Report to Committee

Date: December 18, 2018
File: RZ 16-733904

Re: Application by Interface Architecture Inc. for Rezoning at 5631, 5635, 5651, 5691, 5711, 5731 and 5751 Steveston Highway from "Single Detached (RS1/B)" Zone and "Single Detached (RS1/E)" Zone to "Medium Density Townhouses (RTM2)" Zone

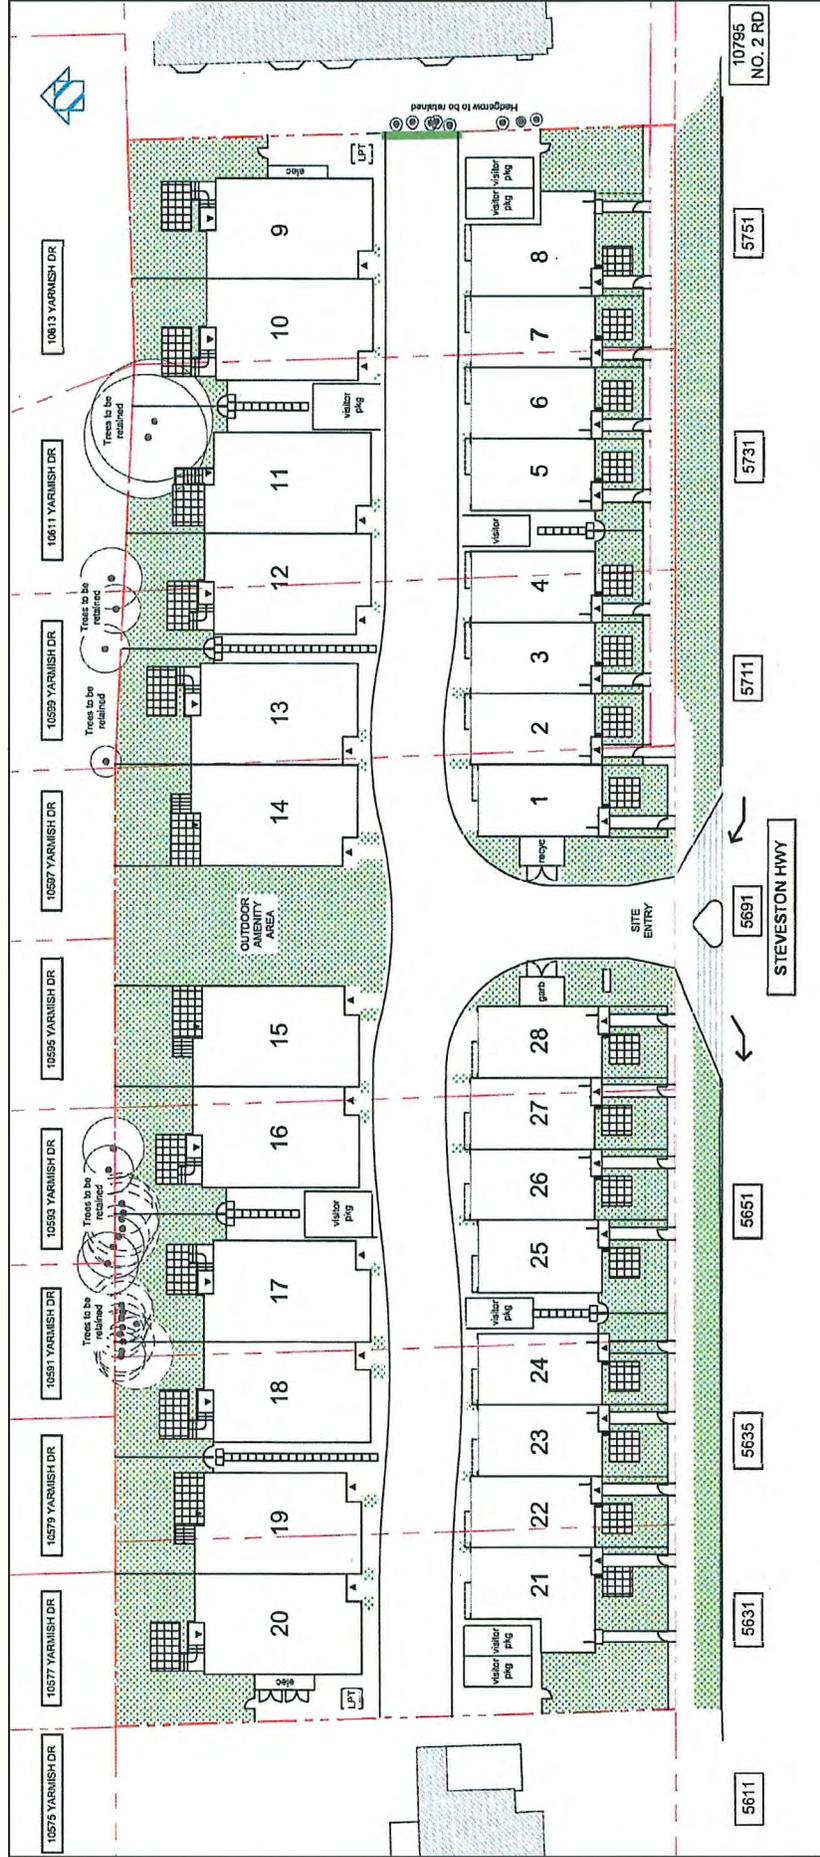
Neighbour Address: 10575 Yarmish Dr. Comments: Higher fencing for better security, More trees for privacy.

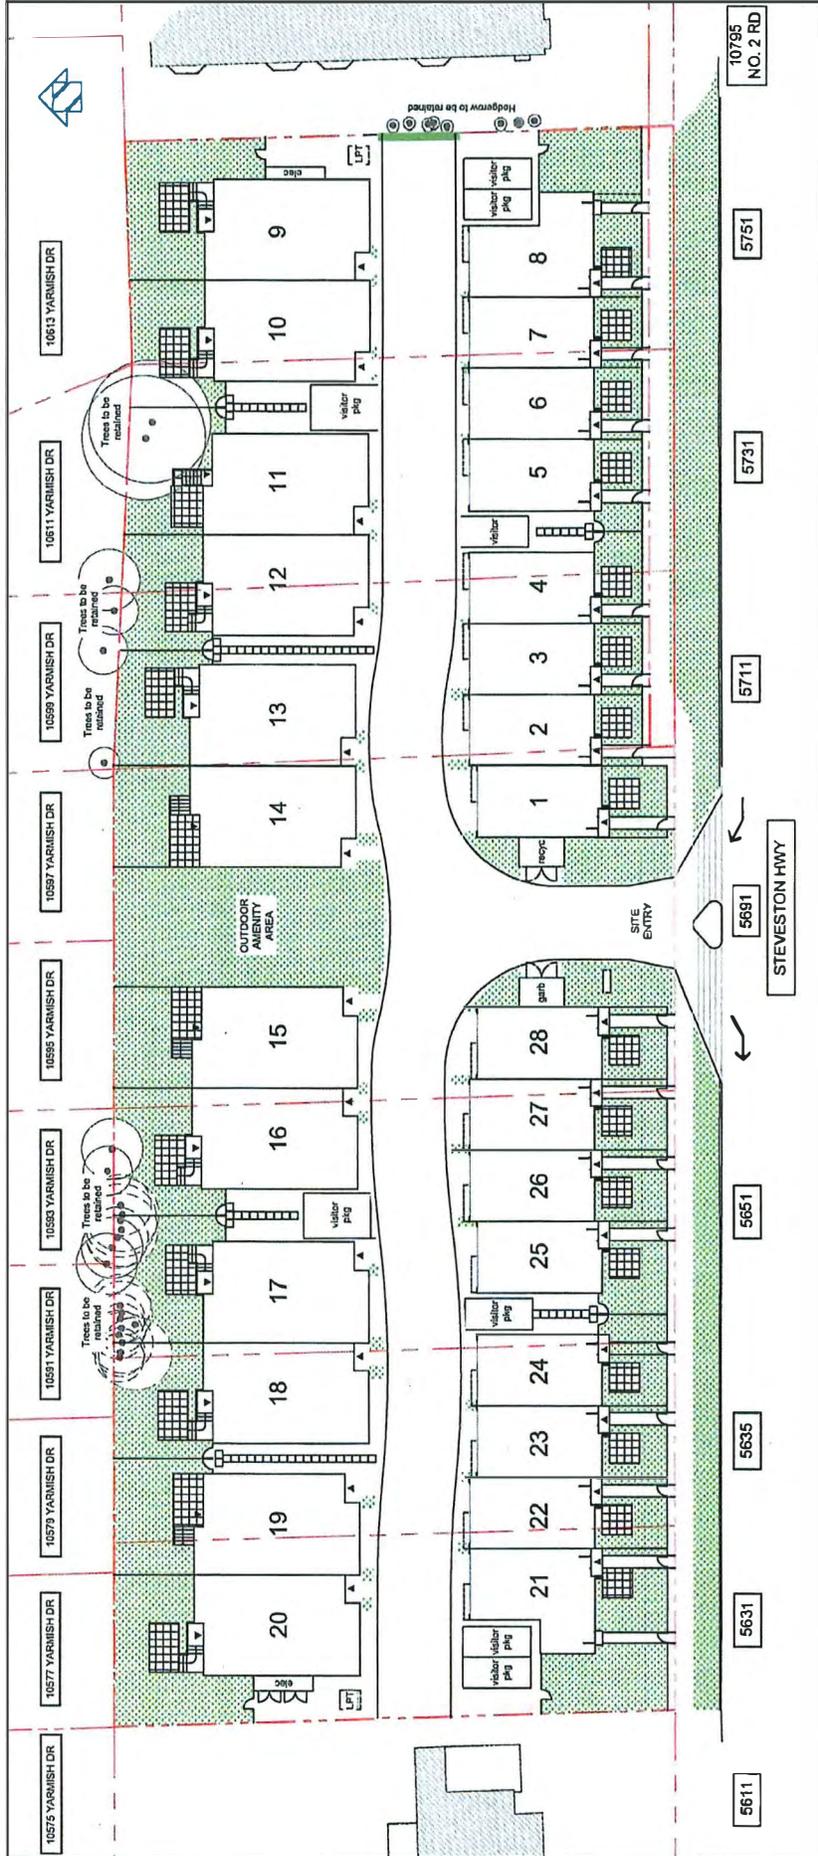
Neighbour Address: 10579 Comments: Replacement of roof fencing / tree trimming

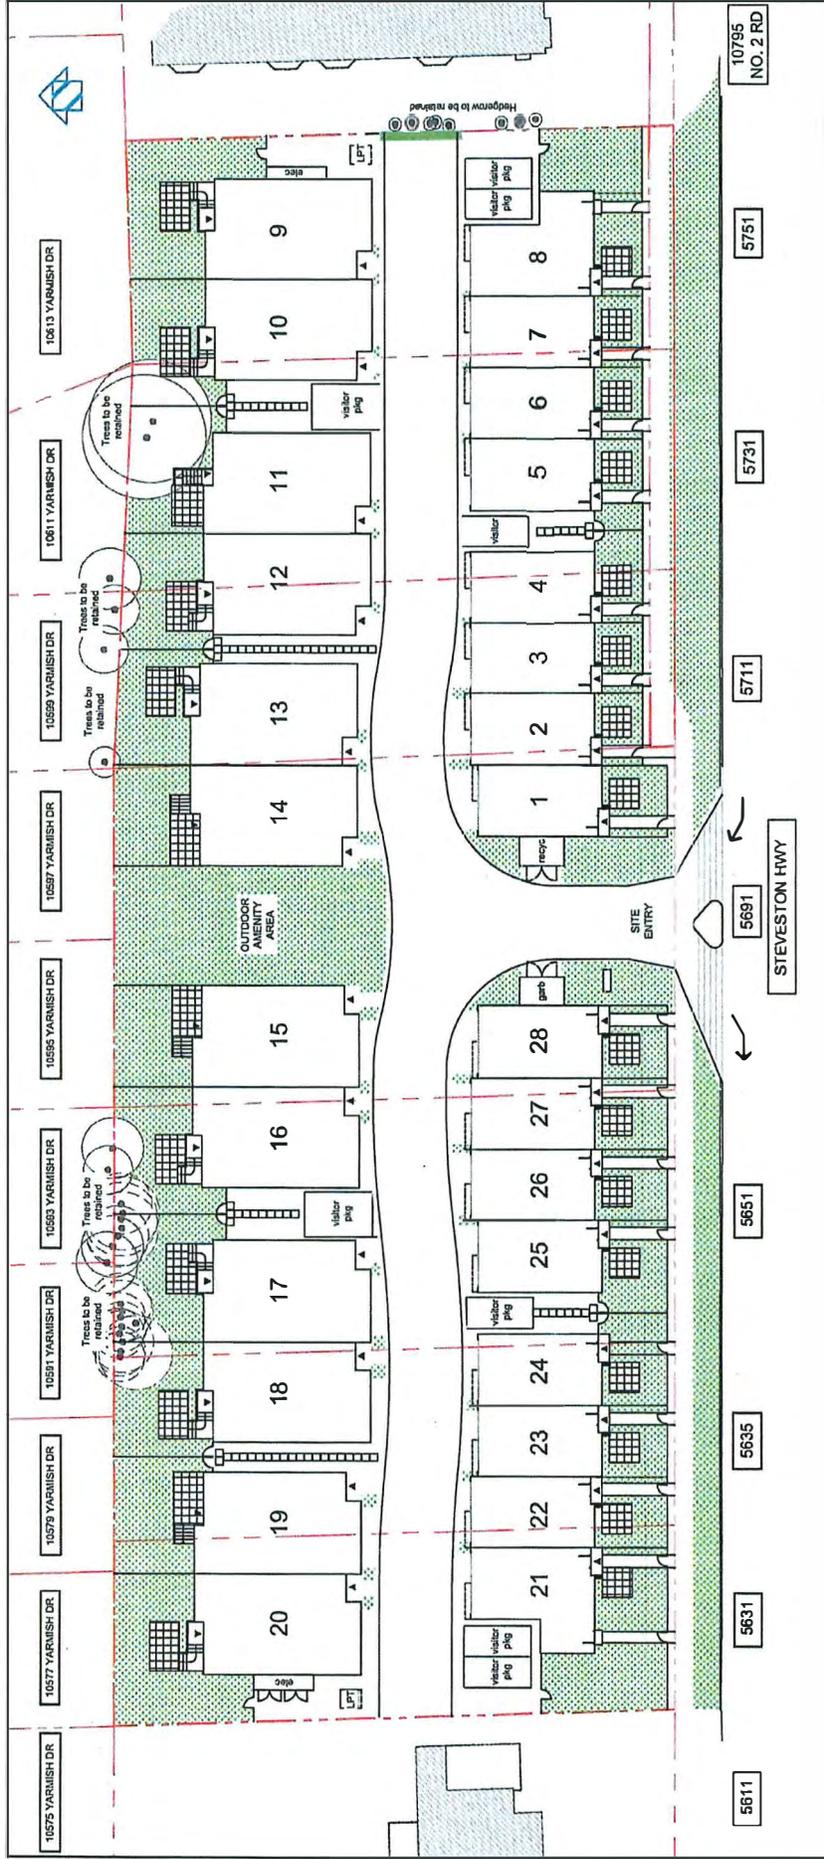
Neighbour Address: 10611. Comments: Security / more info. / Fence height
